HORSHAM DISTRICT COUNCIL CONSULTATION

TO:	Horsham District Council – Planning Dept
LOCATION:	Ransoms Station Road Pulborough West Sussex
DESCRIPTION:	Application for Approval of Details Reserved by Conditions 14 and 21 to approved application DC/22/1059
REFERENCE:	DISC/25/0228
RE-CONSULT:	1st set of comments in black 2nd set of comments in blue
RECOMMENDATION:	More Information / Modification Advice

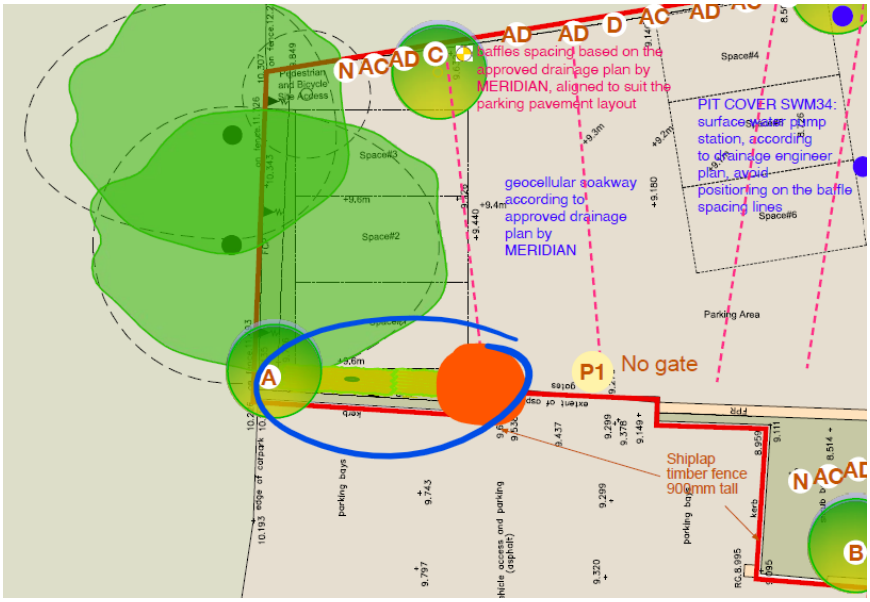
1. Please move tree A to the location highlighted in orange, in order to prevent competition with the existing trees. Also clarify what is the shrub planting proposed along space#1 and circled in blue below. And identify planting bed width within the proposed planting along the northern boundary.

Tree A moved, with thanks.

We note within the applicant's response, dated October 2025, that the width of the planting bed is 1-1.5m, however this needs to be clearly marked in plan. For example, there does not appear to be 1m available space between Space#4 and the red line boundary.

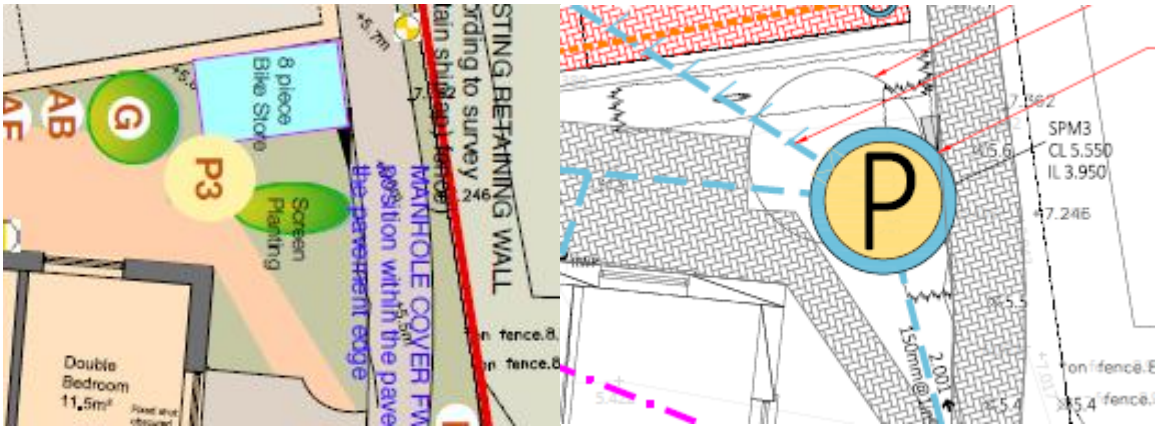
14. Not provided. Drainage layout plan under DC/22/1059 doesn't appear coordinated with the landscape proposals. For instance, tree indicated as G appears to clash with a proposed pipe, see extract below

Closed, with thanks.
